Ballyalbaney & Horseshoe Bridges

Stage 1 Quality Audit

Monaghan County Council

April 2023

Figure 3-1 – In-Line Crossing Arrangement

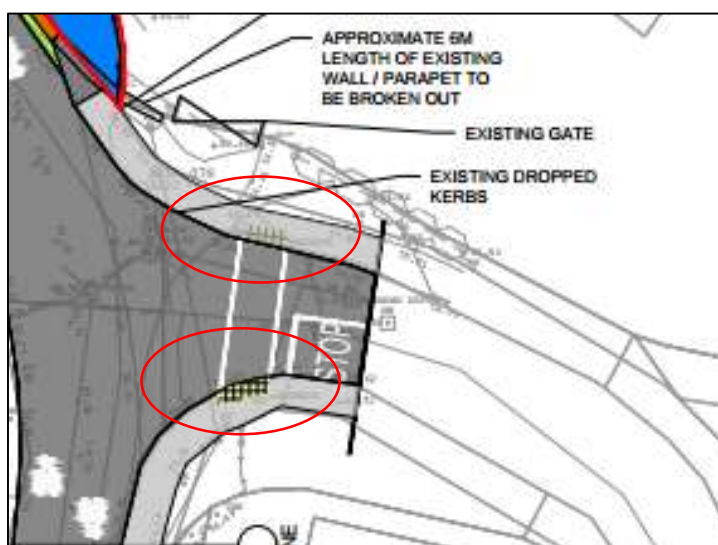
3.1.1. Problem: In-Line Crossing Arrangement

The proposed crossing is considered an 'in-line' crossing at Coolshannagh Walk Junction at Ballyalbaney Bridge. The proposed tactile paving may not provide sufficient warning to visually impaired road users who may inadvertently step over the 800mm tactile zone and walk straight onto the carriageway where they could be struck by vehicles.

The Designer should extend the depth of the tactiles in accordance with best practice to 3 tactiles deep at all inline crossings.

Paragraph No. in Safety Audit Report	To be completed by the Designer			To be completed by the Audit Team
	Problem accepted (yes/no)	Recommended measure accepted (yes/no)	Alternative measures or comments	Alternative Measures accepted by Auditors (yes/no)
3.1	Yes	Yes		
3.2	Yes	Yes		
3.3	Yes	Yes. Pilasters will be introduced to remove this issue.		Yes
3.4	Yes	Yes. Pilasters will be introduced to remove this issue.		Yes
3.5	Yes	Yes		
3.6	Yes	Yes		
3.7	Yes	Yes

Figure 3-2 – Proposed Concrete Footpath

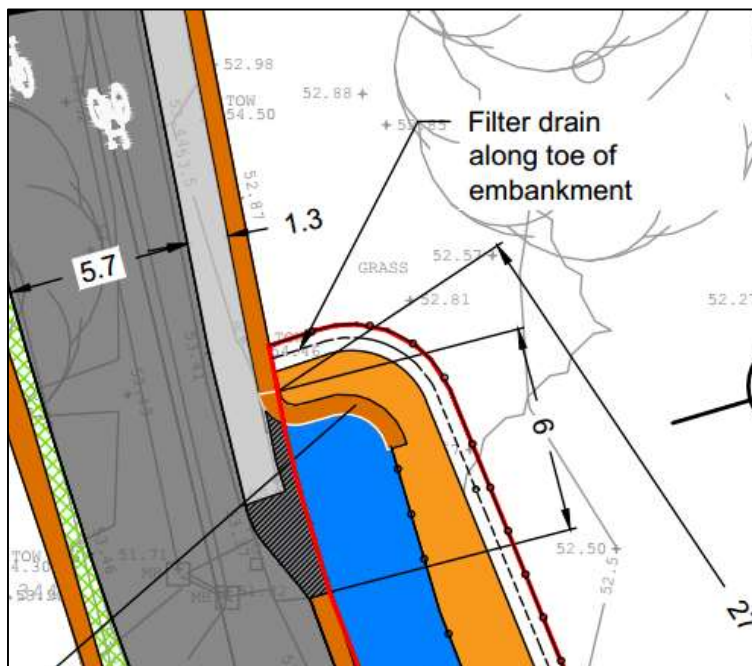
3.1.2. Problem: Concrete Joints

The designer has indicated the presence a proposed infill of concrete between the existing footpath and proposed bridge footway. The infill / modest additions of concrete may lead to a number of increase joints and potential trip hazards.

The Designer should extend the concrete footpath to eliminate number of joints within tie-in areas.

Figure 3-3 – Proposed Parapet

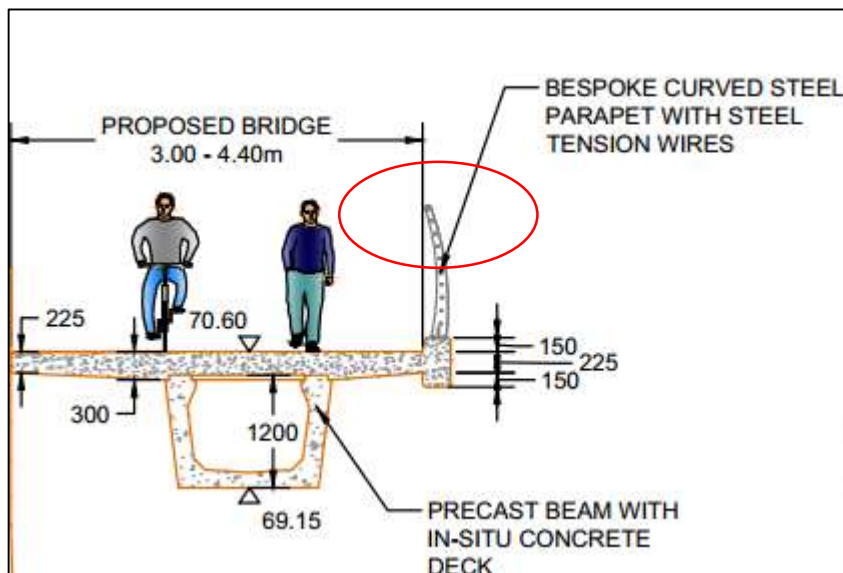
3.1.3. Problem: Snagging from parapet end

The design drawings show a parapet as shown below **Figure 3-3**. If the parapet end is not suitably transitioned/ terminated this may leave sections of the parapet where pedestrians may become snagged which could result in pedestrian injury.

The Designer should ensure the end of each parapet are designed to prevent any snagging on the end/ beginning of parapets.

Figure 3-4 – Proposed Parapet

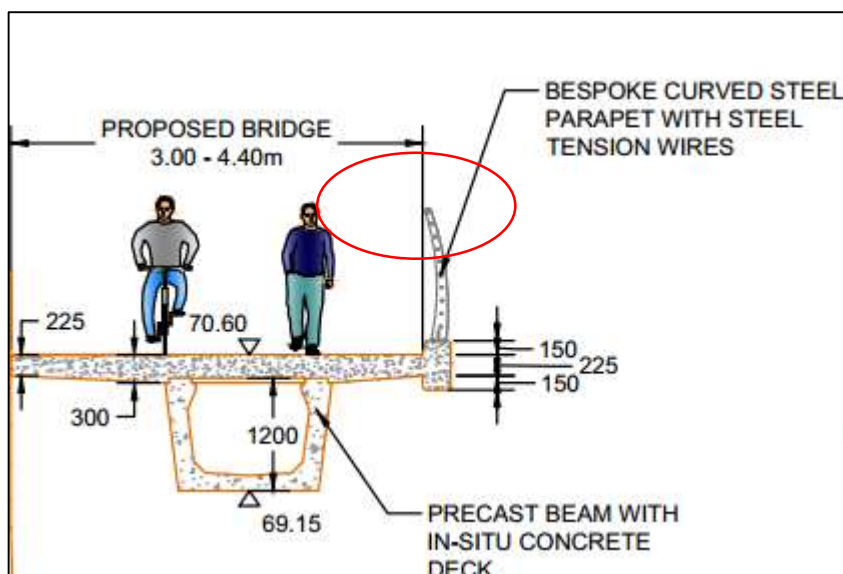
3.1.4. Problem: Snagging from parapet end

The design drawings show a parapet as shown below Figure 3-6. If the parapet end is not suitably transitioned/terminated into the proposed fence smoothly this may leave sections of the parapet where pedestrians may become snagged which could result in pedestrian injury.

The Designer should ensure the end of each parapet are designed to prevent any snagging on the end/ beginning of parapets.

Figure 3-6 – Visibility at Shared Area

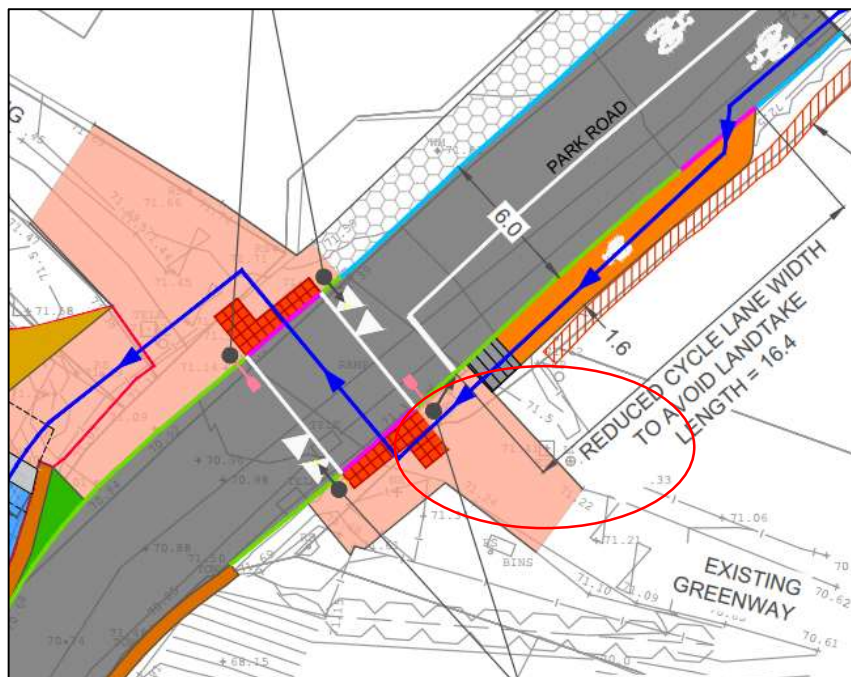
3.1.6. Problem: Space in shared area

The area for cyclists entering the shared area from the cycle track as shown in **Figure 3-6** appears small. This could result in cyclists coming into conflict pedestrians and cyclists from the greenway where adequate space does not exist.

The Designer should consider extending the shared area at this location so as to reduce risk of conflict.

Figure 3-1 – Indicative area of chamber and footpath

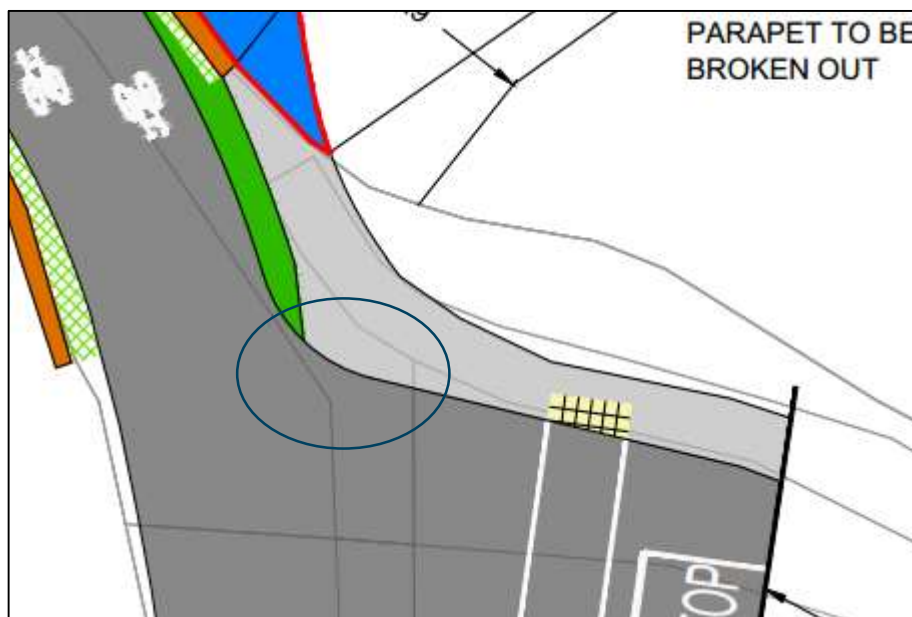
3.1.7. Problem: Existing Chamber in Proposed Footpath

The proposed footpath widening intersects with an existing utility chamber as shown in Figure 3-7 below. If the existing utility chamber is not raised and plumbed with the proposed footpath appropriately this may lead to trips and falls of pedestrians over the lid and frame of the chamber.

The Designer should ensure the chamber is catered for as part of the proposed works.

Figure 2-3 – Existing Footpath

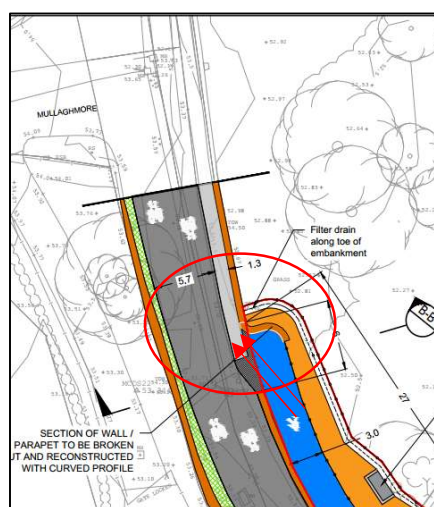
2.2. Problem: Sudden narrowing of footpath

The proposed footway is over 3m along the bridge and then narrows suddenly to 1.3m at the existing footpath as shown in Figure 2-3. If pedestrians meet along this section of existing footpath or people walk side-by-side across the bridge, it is likely the person on the LHS / outside would have to step onto the carriageway and may come into conflict with traffic coming from the north.

Recommendation: The Designer should investigate measures to gradually reduce the footpath over a longer distance and reduce the chance of people stepping onto the road due to the sudden narrowing.

2.1	Yes	Yes		
2.2	Yes	No	<p>A GPR survey of the graveyard has indicated the potential presence of an unmarked grave at the north end of the embankment.</p> <p>The proposed footpath to embankment connection at this point incorporates a footpath taper and the removal of 6m (approx.) of boundary wall. This arrangement seeks to provide sufficient space for pedestrians to pass without stepping onto the road.</p> <p>The existing footpath and proposed embankment will be at the same level (approx.).</p> <p>Footpath users will generally have advanced visibility of approaching pedestrians in both directions.</p>	Yes. The layout maximises the available space considering constraints present.

Figure 2-6 – Desire Line

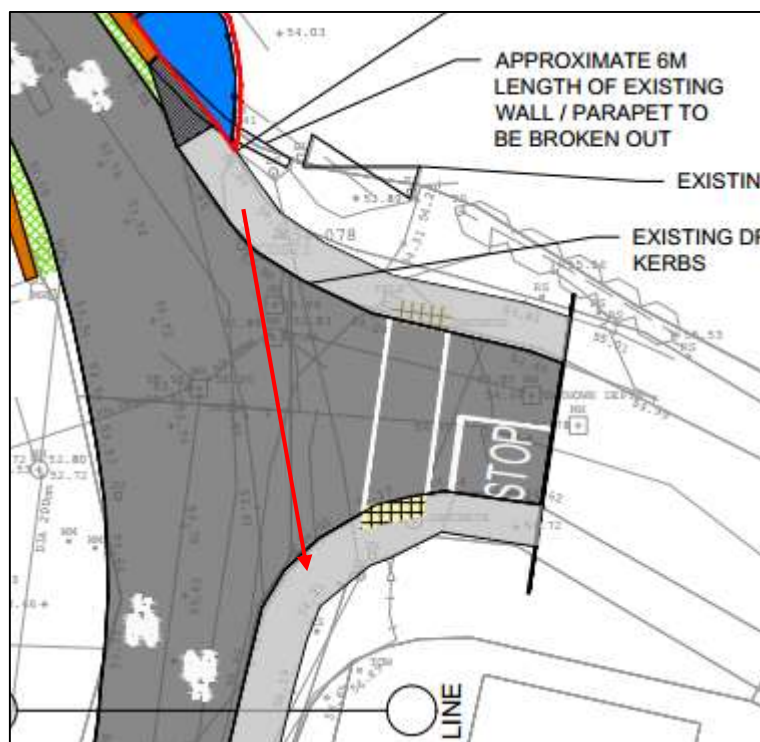
2.5. Problem: Desire line

The proposed pedestrian crossing at Coolshannagh Walk Junction does not appear to be along the natural desire line for pedestrians. There is a risk of slips, trips and falls where adequate provision is not made for the natural desire line. Additionally, where provision is not adequate, some may choose to walk on the trafficked lanes where they may be at risk of coming into conflict with traffic.

Recommendation: The proposals should ensure there is adequate provision along the natural desire line in terms of tactile paving and dropped kerbs, to ensure vulnerable road users can safely travel across the site.

2.5	Yes	No	Junction narrowing was explored as part of the Option development process. This was not possible due to the operational requirements of Leonards Steel Ltd. Leonards Steel receive and deliver long-loads on trombone trailers. An auto tracking exercise was undertaken to check the compatibility of a junction narrowing with their delivery vehicles. The result showed that this would lead to areas of footpath over-ride. Please refer to Section 6.6 of the Options Selection Report for the results of the analysis (5213957DG0007 Rev 4). The tactile paving flags at the proposed crossing point will be specified to be a minimum of 3 units deep.	Yes. The layout maximises the available space considering constraints present

Figure 2-8 – Mullaghmatt Road

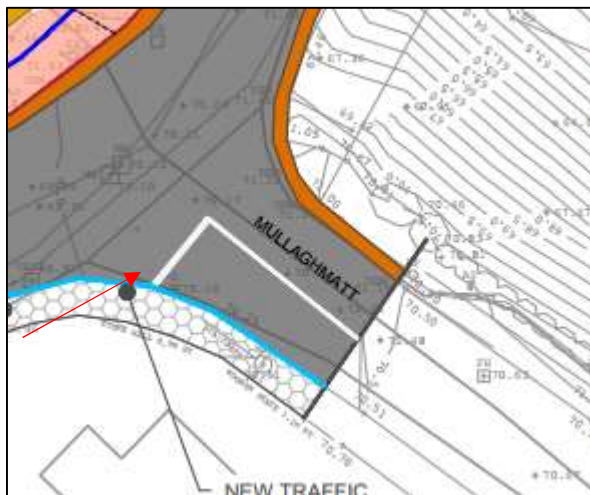
2.7. Problem: Stop line position

The proposed stop line position extends into the opening of the junction. If vehicles travelling north/south from Park Road enter the junction to travel east on Mullaghmatt Road, they may be restricted by waiting vehicles at the stop line on Mullaghmatt Road. This may lead to shunt collisions between vehicles as a result of blockages of the Park Road and the junction.

Recommendation: The Designer should ensure the stop line is set back to allow for access for vehicles onto Mullaghmatt Road from Park Road.

2.7	Yes	Yes.

To be completed by the Designer		To be completed by the Audit Team
Paragraph No. in Safety Audit Report	Problem accepted (yes/no)	Recommended measure accepted (yes/no)	Alternative measures (describe)	Alternative Measures accepted by Auditors (yes/no)
		The side road is quite narrow. The stop line location will be optimised at the Detailed Design stage.		
Problems Identified in Road Safety Audit Addendum				
4.1	Yes	Yes.		
4.2	Yes	Yes. It is intended to incorporate a jug handle junction for the cyclists so that they enter onto the carriageway perpendicularly. Due to space constraints, it may require some shared use of the existing footpath. This is not shown on the Preliminary Design drawing and will be detailed further at DD stage.		Yes.
4.3	Yes	Yes. The treatment of cyclists crossing the junction will be re-examined for potential improvement at DD Stage.		Yes.

Figure 4-2 – Proposed Drop Kerb for Cyclists

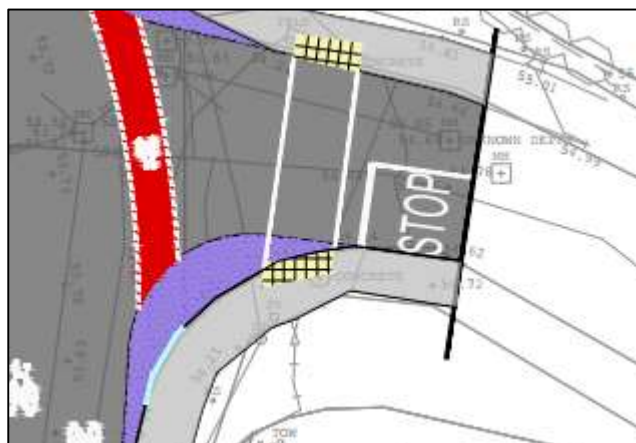
4.2. Problem: Proposed drop kerb

The proposed dropped kerb at the location in figure 4-2 encourages cyclists to enter onto the footpath. The layout may create confusion for cyclists and lead to conflict between pedestrians and cyclists.

The dropped kerb should be removed at this location.

Figure 4-3 – Proposed online cycle lane

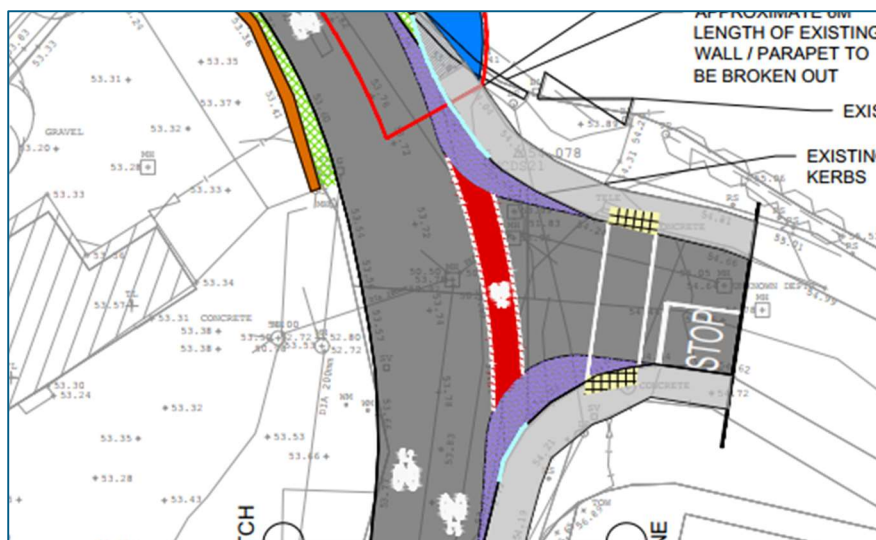
4.3. Problem: Proposed online cycle lane

The proposed online cycle track appears to start and end abruptly shortly at the junction. It appears that cyclists may abruptly enter the carriageway which is not expected by drivers who may be turning into Coolshannagh Walk. At the south of the cycle track, there is an abrupt end which abuts the footpath that may lead to cyclist abruptly merging to the road where conflict may arise.

The Designer should review the proposed layout and propose a detail that allows adequate provision for cyclists to cross the junction while also interacting with traffic and also requiring them to merge safely to the south of the scheme.
